SAFETY RECALL BULLETIN

NHTSA RECALL 25V036

AUTOCAR, LLC DC-2502

Autocar, LLC has decided that a safety issue exists with the cab shock absorber mounting bracket fasteners on certain 2020-2026 model year DC (Legend) vehicles.

Figure 1

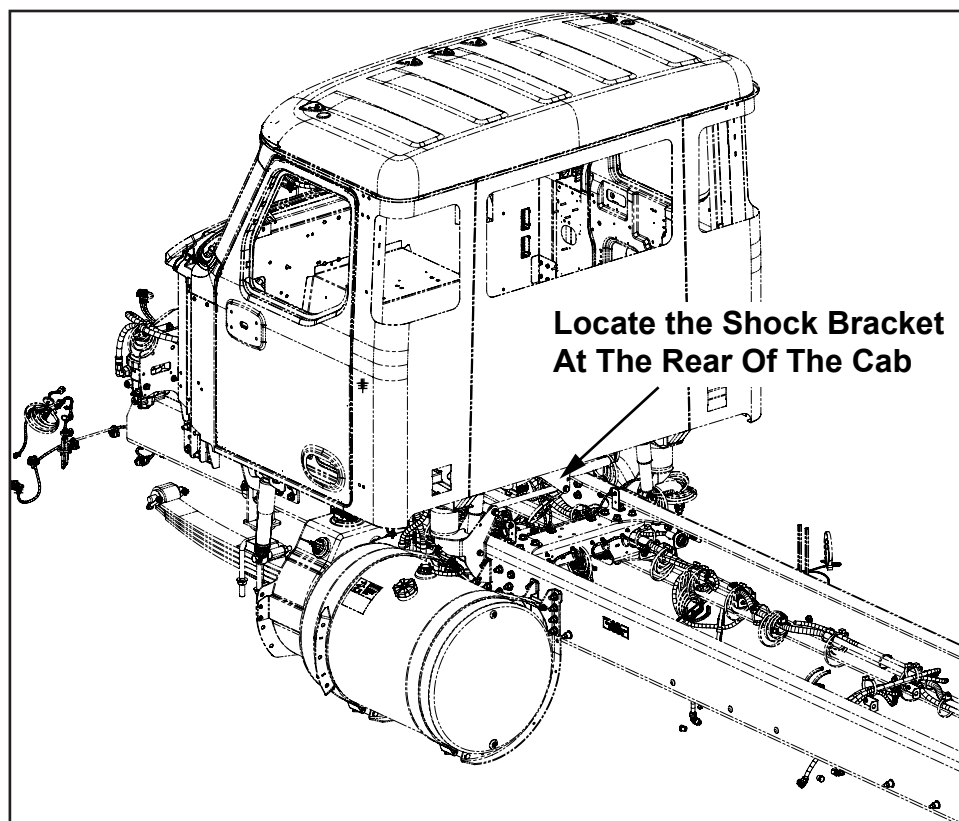
1. Follow all lockout/tagout procedures and verify the battery disconnect switch is in the "OFF" position. If the unit is not equipped with a battery disconnect switch, disconnect the battery cables beginning with the negative cables, followed by the positive cables.
2. Locate the cab shock bracket at the rear underside of the cab (see Figure 1).

Figure 2

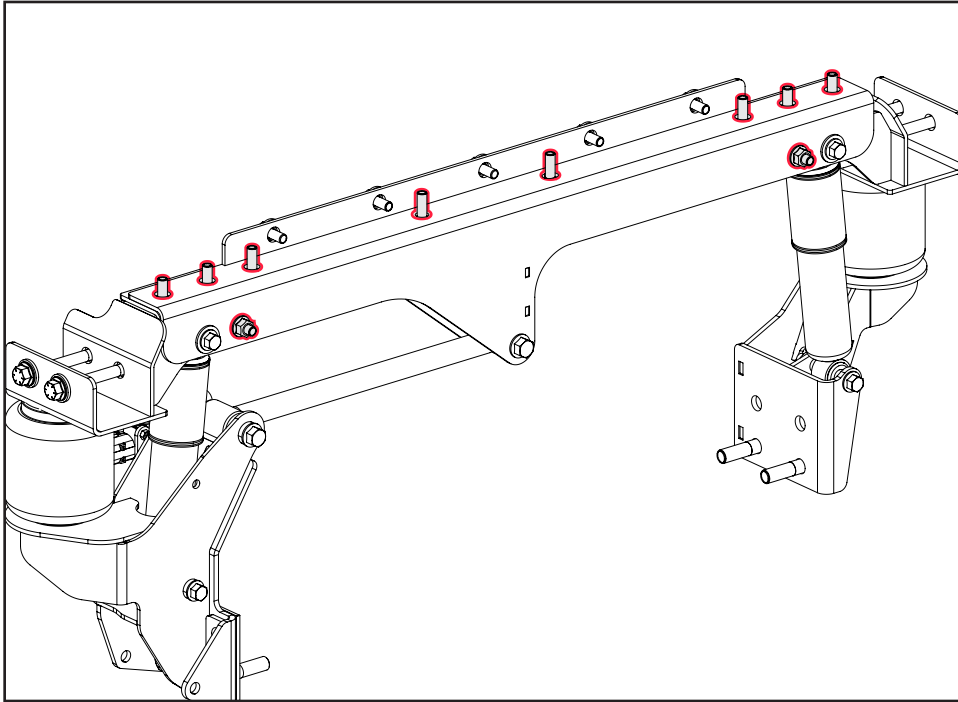
3. Locate eight vertical and two horizontal fasteners and tighten to 37 Lbs.-Ft of torque (see Figure 2).

Note: If additional fasteners are required, obtain locally using common grade 8 hardware. If you have questions or concerns, please contact Autocar Technical Support at 888-218-3611
